ADDENDUM NO. 002 (Rev 01/2017)

ISSUE DATE: **03/12/2024**

RE: **GRAINGER HALL 2ND & 5TH FLOOR RENOVATION
PHASE 2 - 5TH FLOOR OFFICE RENOVATION &
PHASE 3 - 2ND FLOOR NW CORNER RENOVATION
UNIVERSITY OF WISCONSIN-MADISON
610 WALNUT STREET
MADISON, WISCONSIN**

UWSA Project No. **A-22-021**
UW Madison Project No. **0140-2303**

3 ENLARGED RCP AT CEILING ELEMENT AS-3
1/2" = 1'-0"

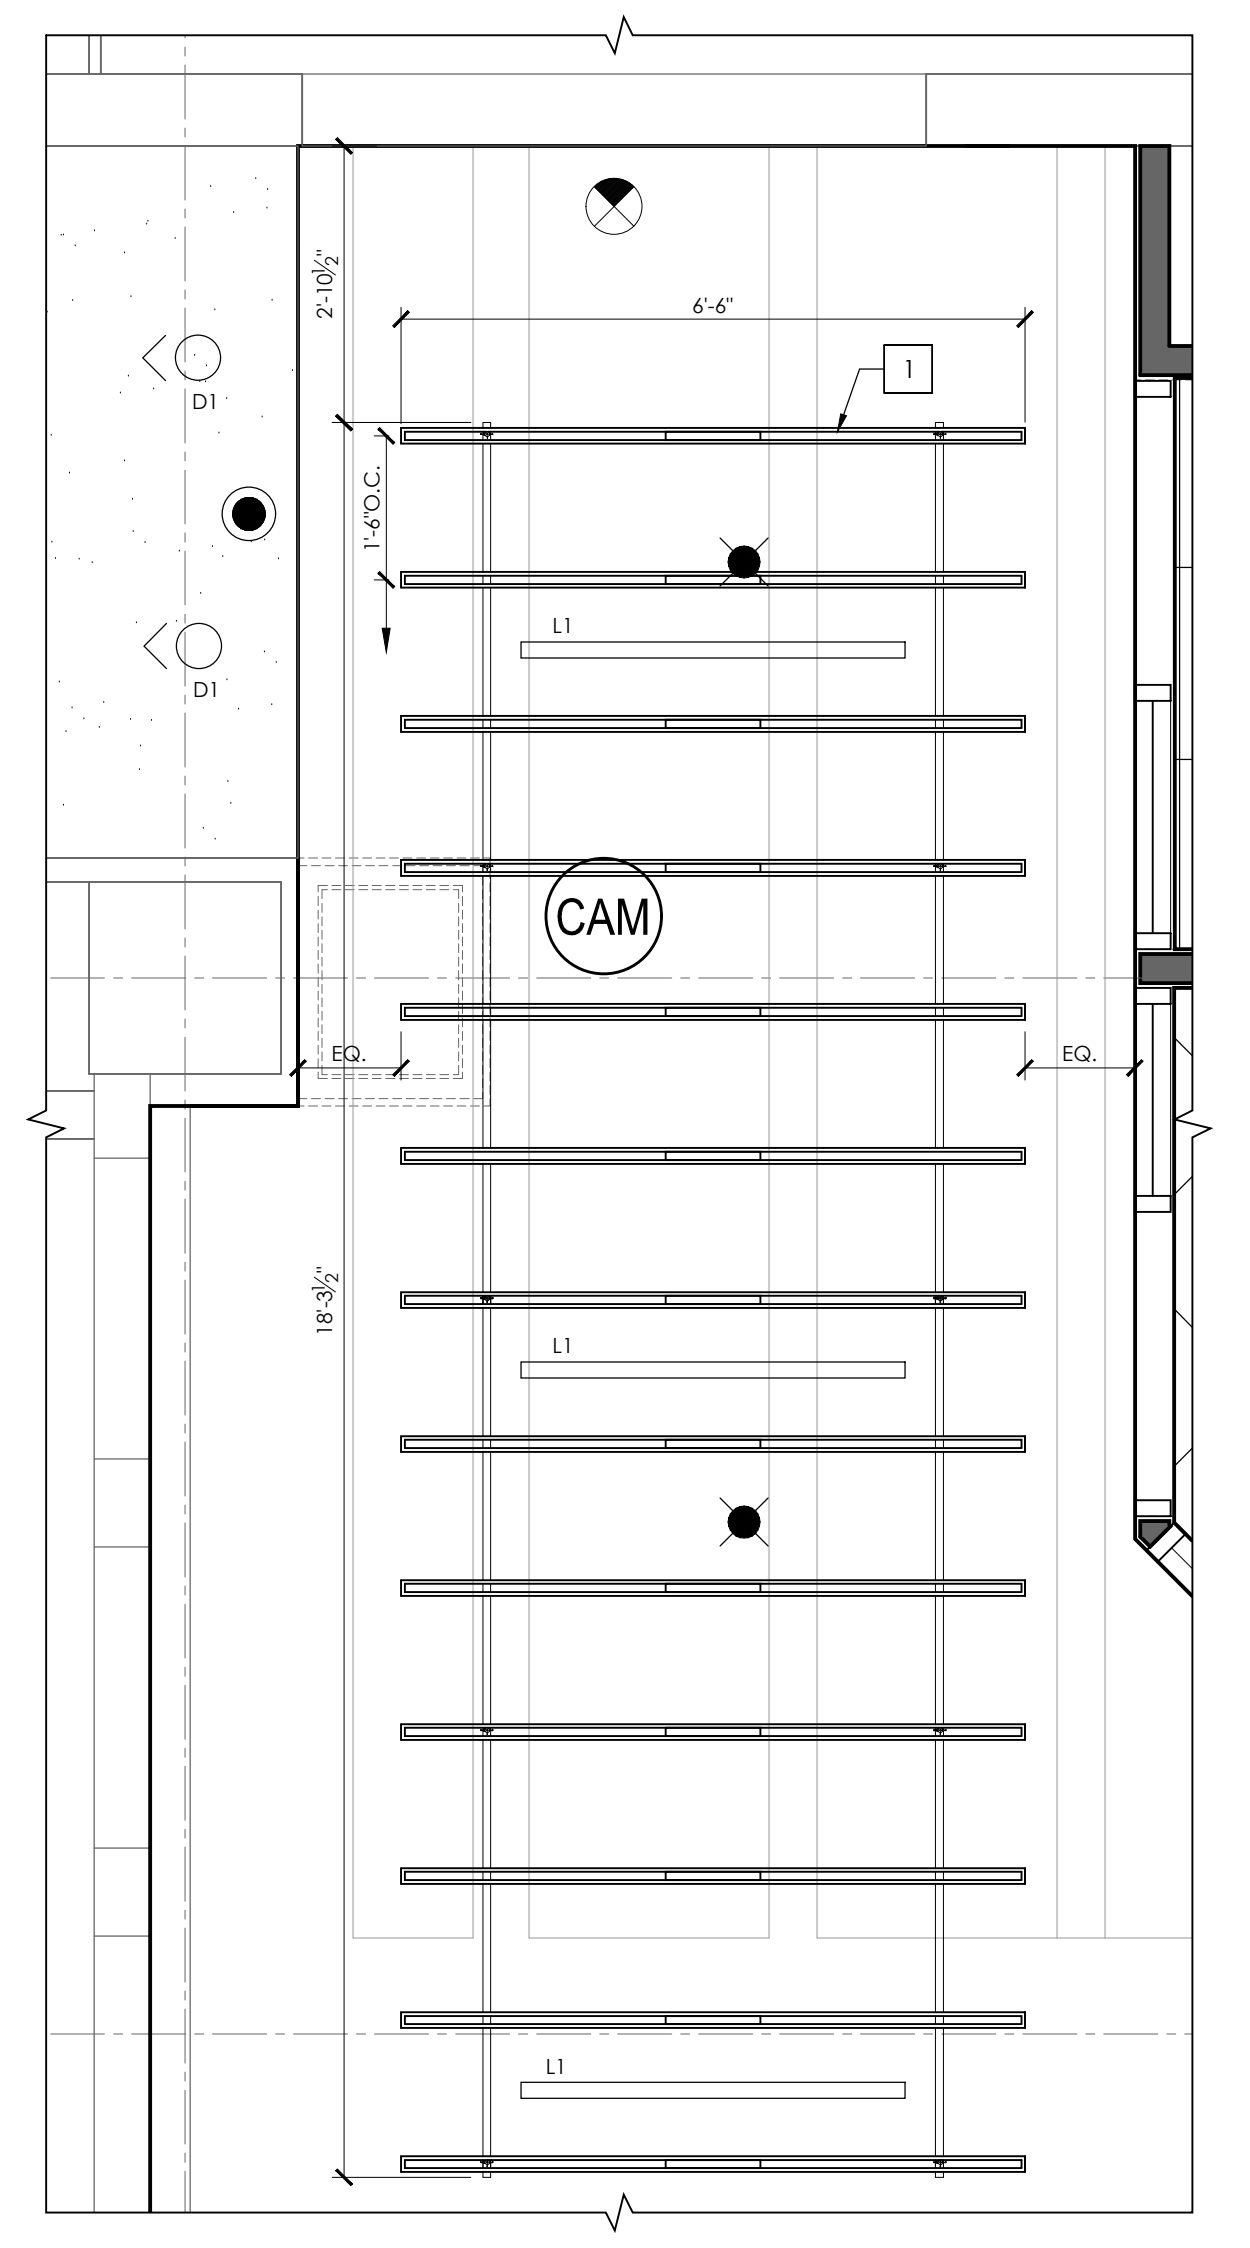
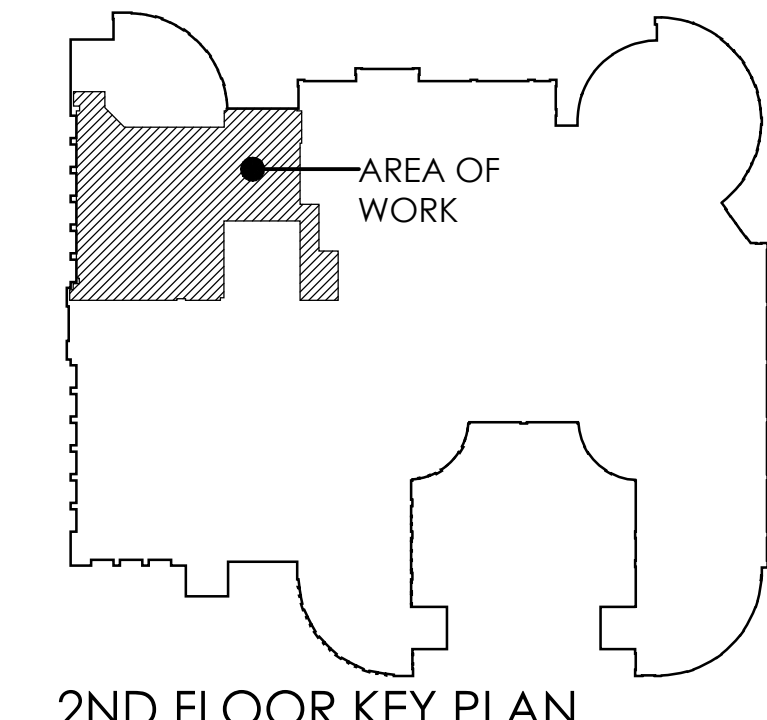
- a. Sheet A201.
 - i. **ADD:** Add keynote 9. Keynote to read, " GPC to demo the GWB ceiling as needed for the above ceiling plumbing and mechanical work. GPC to install GWB and paint the entire ceiling PT-7." See Sheet A201.

- AS-1 SUSPENDED FROM EXPOSED CLG 9'-4" A.F.F
- AS-2 SUSPENDED FROM EXPOSED CLG 9'-4" A.F.F
- AS-3 SUSPENDED FROM EXPOSED CLG 8'-7" A.F.F
- SLAT SYSTEM. SEE ASSOCIATED INTERIOR ELEVATIONS AND DETAILS
- RECESSED PROJECTOR. SEE ASSOCIATED DETAIL
- REPAIR XTG GWB SOFFIT. PAINT GWB PT-11 AND MATCH GWB TEXTURE OF XTG SOFFIT
- GWB AT COVE LIGHT CONDITIONS IN ROOM TO BE PAINTED PT-6
- NEW GWB AT XTG FRAMING PAINTED PT-4
- GPC TO DEMO THE GWB CEILING AS NEEDED FOR THE ABOVE CEILING PLUMBING AND MECHANICAL WORK. GPC TO INSTALL NEW GWB AND PAINT THE ENTIRE CEILING PT-7.

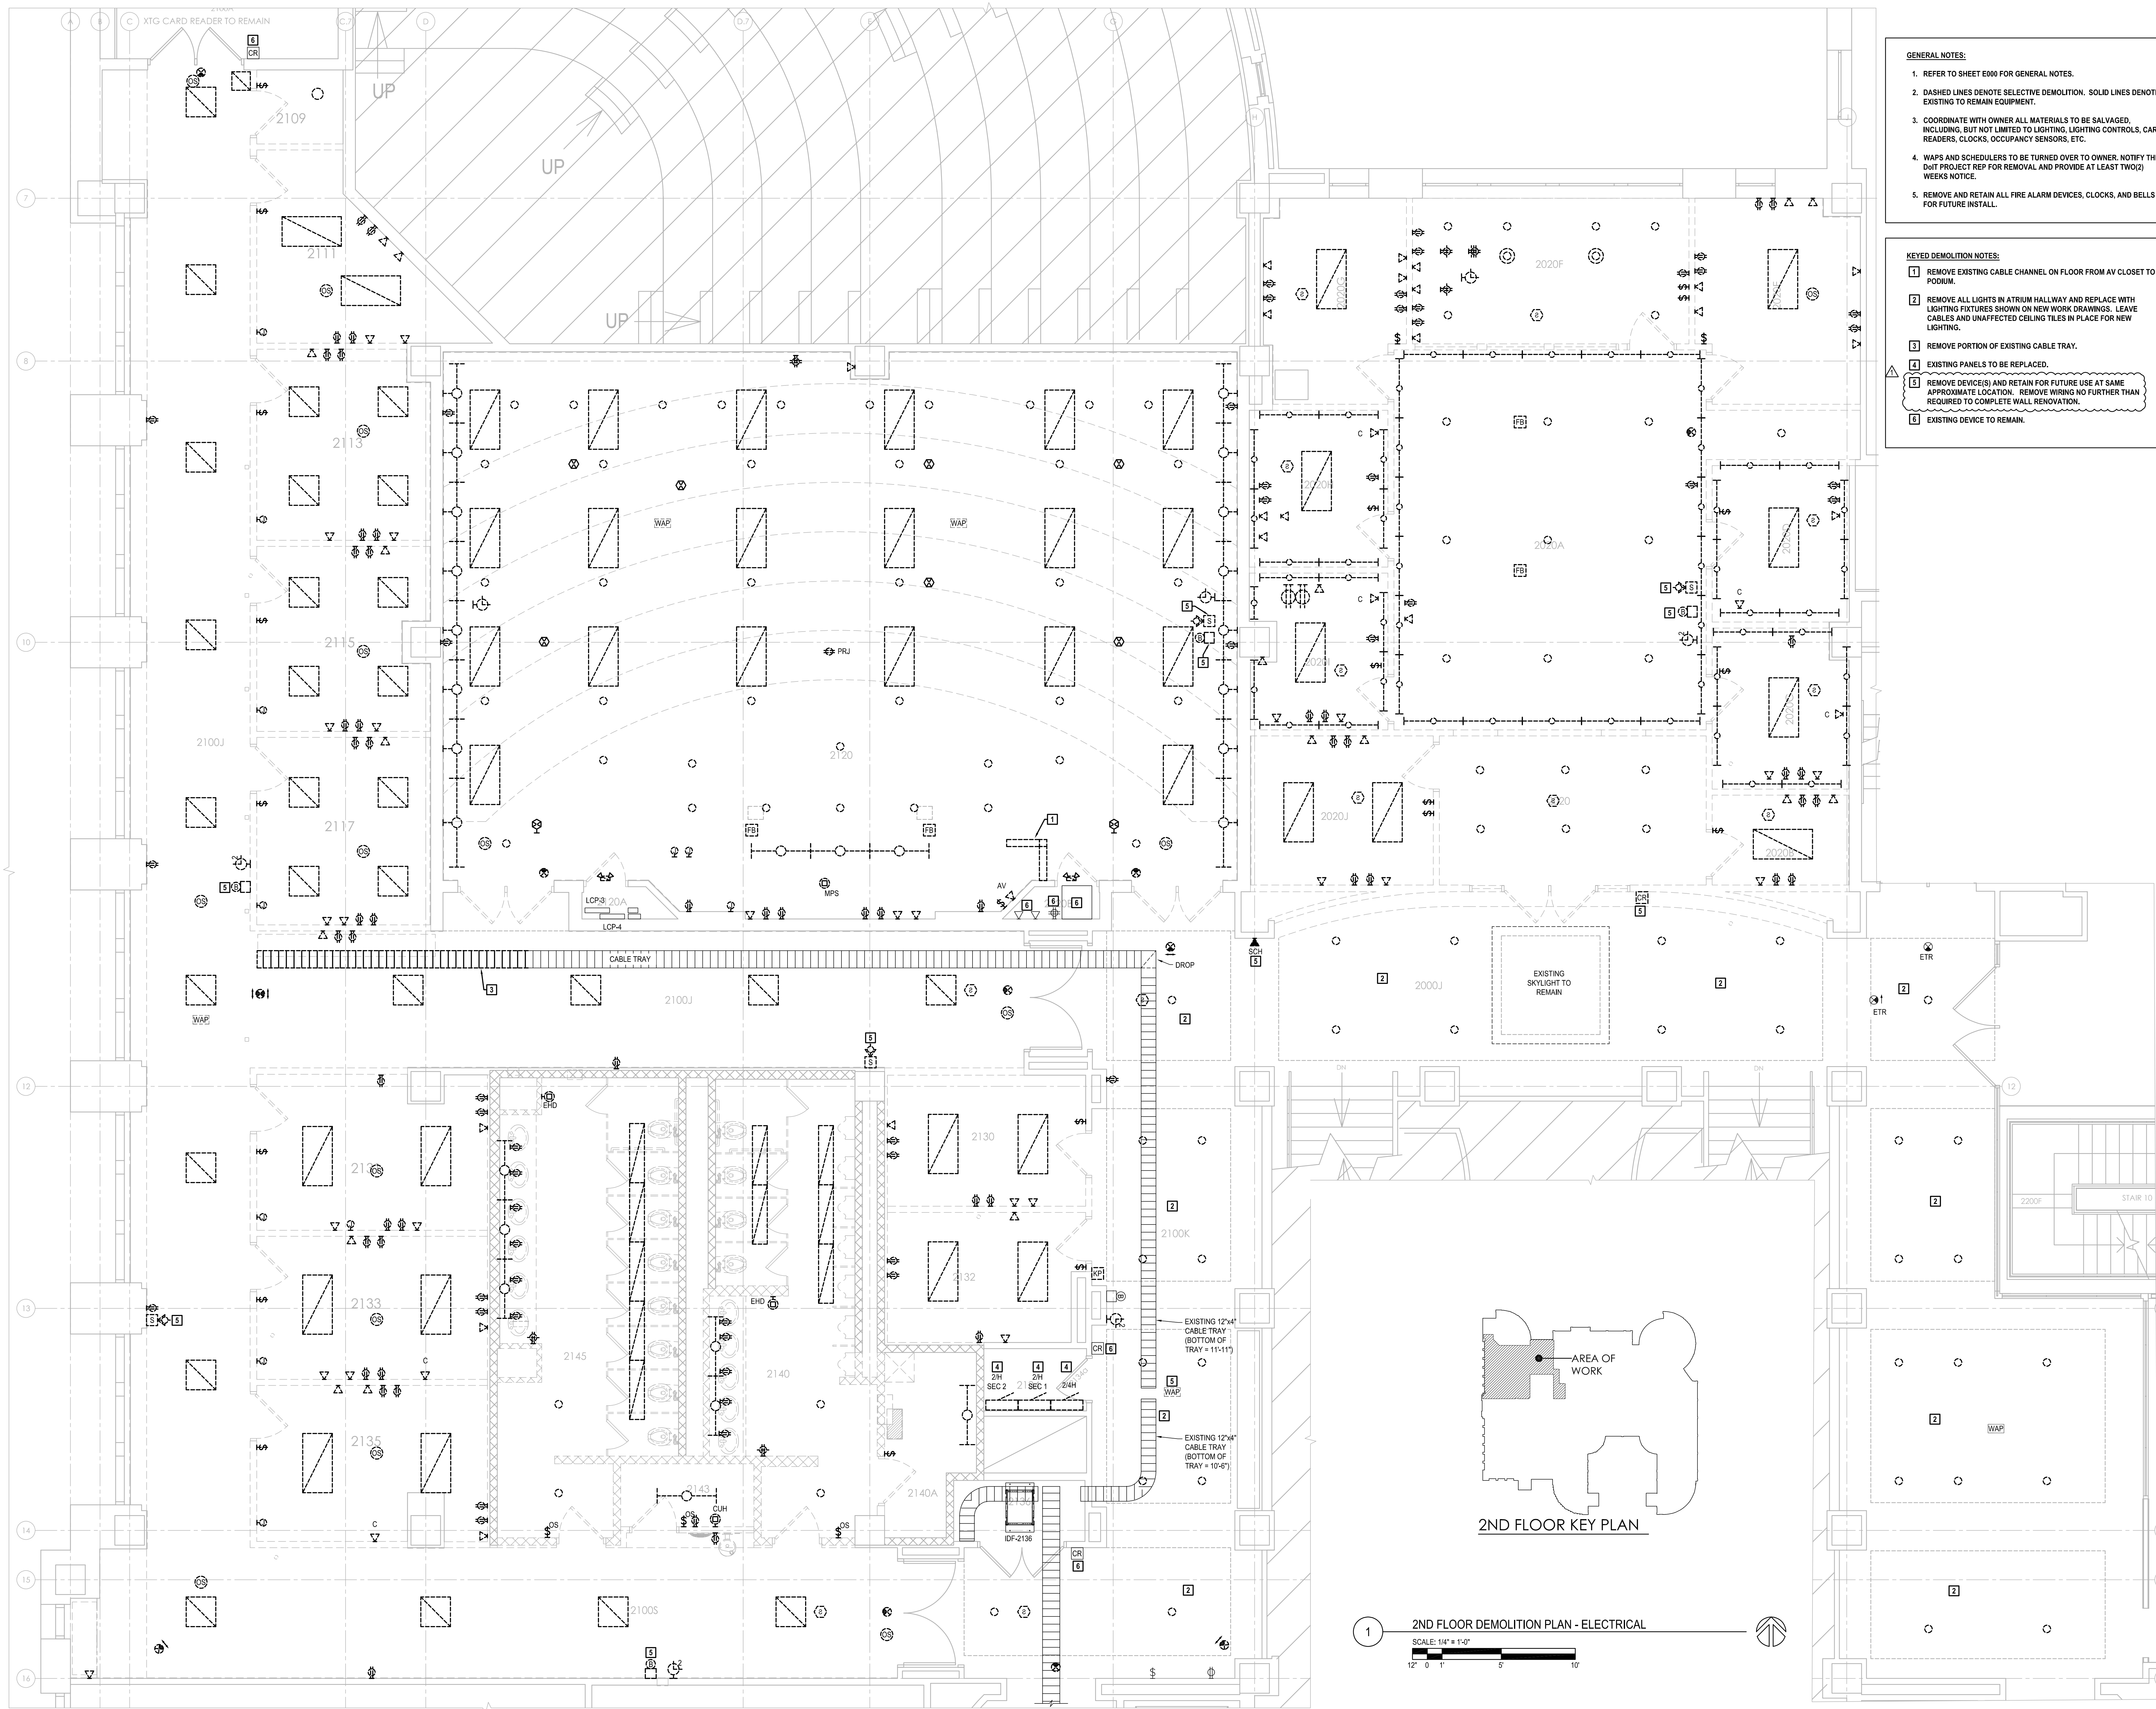
- b. Sheet E000
 - i. **REVISE:** The lighting fixture schedule has been updated with notes in regard to the size of the Mutto Light Fixture Size so that the larger 16.5" diameter fixture is to be used. See Sheet E000.

- ii. **REVISE:** The lighting fixture schedule has been updated in regard to the size of the L1B, L1 and L2 fixtures. See Sheet E000.
- c. Sheet ED101

D2	4" APERTURE RECESSED ROUND LED DOWNLIGHT	--	9	LED	4000K	90	1000	ELD	0-10V	10-100%	120V	CEILING	RECESSED	ACT	WITH CEILING FLUSH WITH CEILING	GOTHAM	EV04-WDMIM-40/10-AR-LSS-MVOLT-G210-90CRI		
L1	SUSPENDED LINEAR LED DIRECT/INDIRECT CONTINUOUS RUN LENGTH	ACRYLIC LENS	5.66FT	LED	4000K	90	700FT	ELD	0-10V	1-100%	120V	CEILING	SUSPENDED	VARIES	SEE DWG	LUMENWERX	WA1-5P-D-HLO-0-5D-HLO-SW-90-350-40-CONTINUOUS RUN*UNV-D1-2C-EC-ST5-W		
L2	RECESSED LINEAR LED DIRECT CONTINUOUS RUN LENGTH	ACRYLIC LENS	5.66FT	LED	4000K	90	700FT	ELD	0-10V	1-100%	120V	CEILING	RECESSED	VARIES	SEE DWG	LUMENWERX	WA1-5P-D-HLO-0-5D-SW-90-350-40-CONTINUOUS RUN*UNV-D1-1C-EC-MFM-W		*REFER TO FLOOR PLAN FOR CONTINUOUS RUN LENGTHS WITH EMERGENCY SECTIONS.
P2	6" CYLINDER PENDANT			LED	4000K	90		ELD	0-10V	1-100%	120V	CEILING	PENDANT		SEE DWG	GOTHAM	EV06-40/10-AR-LSS-MVOLT-RGH-PCAN45XW-S8-0VHG		
P3	MUTTO FLUID PENDANT LAMP	--	5	LED	3000K	90	260	ELD	0-10V	1-100%	120V	CEILING	PENDANT		SEE DWG	MUTTO	100301994		*THE LARGER OF THE FIXTURE TYPES TO BE
